LIMERICK GENERATING STATION UNITS 1 & 2

DESIGN ASSESSMENT REPORT

REVISION 2 PAGE CHANGES

THIS DAR SET HAS BEEN UPDATED TO
INCLUDE REVISIONS THROUGH 2
DATED 03/83.

FIGURE 7.1-12

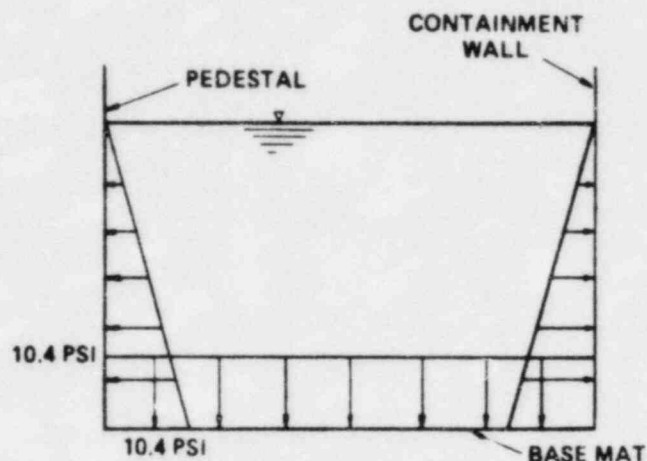
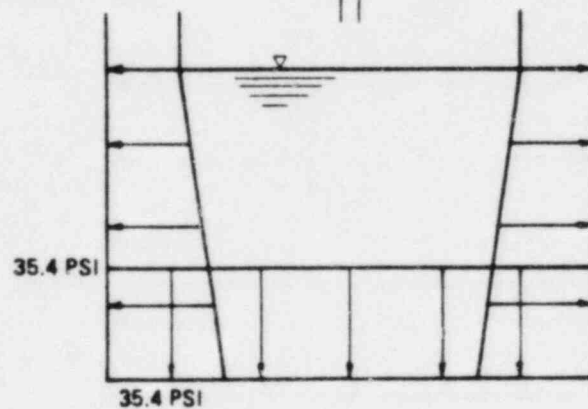
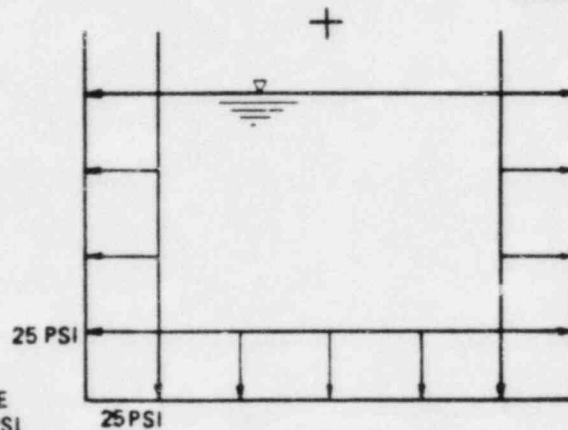
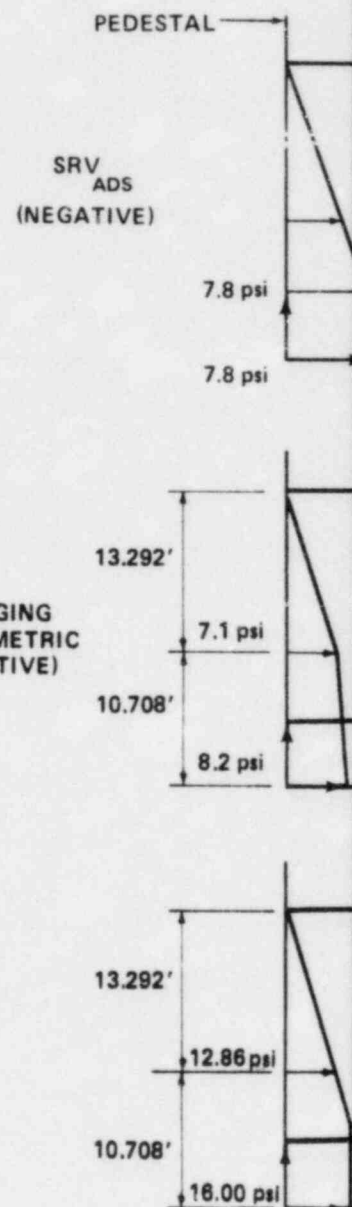
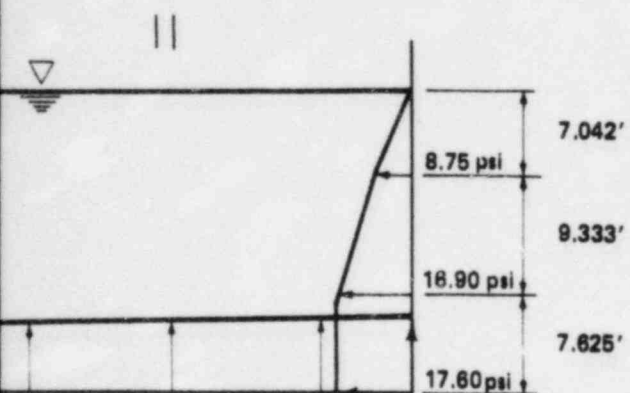
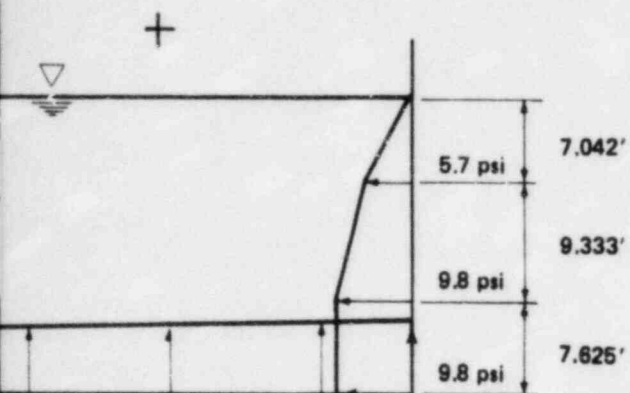
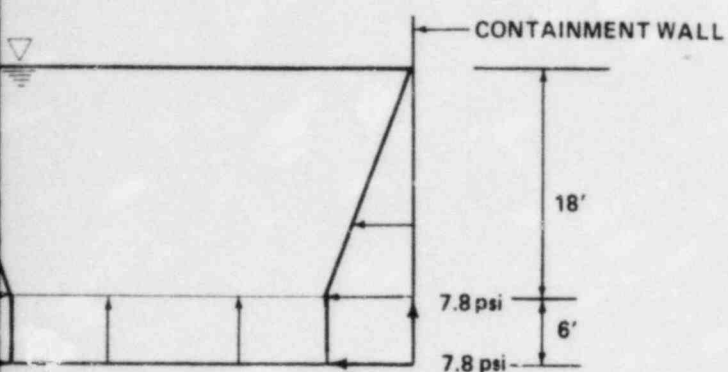
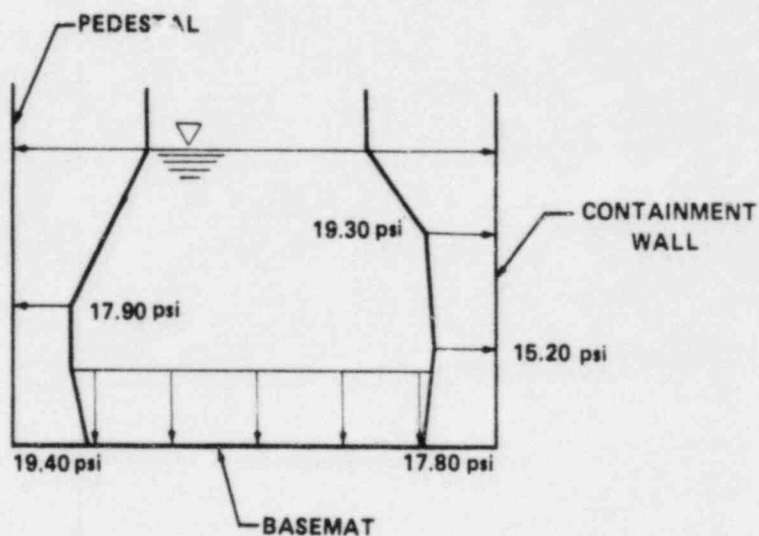
QUESTION 220.20 (DAR Section 7.1.3)

A maximum SRV dynamic negative pressure of 7.8 psi exists on the liner plate based on a consideration of all KWU pressure traces. The pressure is derived from KWU pressure trace No. 76 (Figure 4.1-26) multiplied by a 1.5 pressure multiplier to account for the difference in pool geometries and quencher constructions between Limerick and Brunsbuttel as described in Section 4.1.4.1. This SRV dynamic negative pressure was incorrectly provided in Section 7.1.3 as 11.67 psi and should be corrected to reflect 7.8 psi. When combined with the positive hydrostatic pressure of 10.4 psi, a net positive pressure of 2.6 psi exists on the liner plate.

For the normal condition, the hydrostatic pressure on the basemat liner is 10.4 psi (positive) and the maximum negative pressure due to the actuation of all SRVs is 7.8 psi (negative). The distribution of these pressures on the suppression chamber wall is shown in Figure 7.1-12. The maximum net pressure is 2.6 psi (positive).
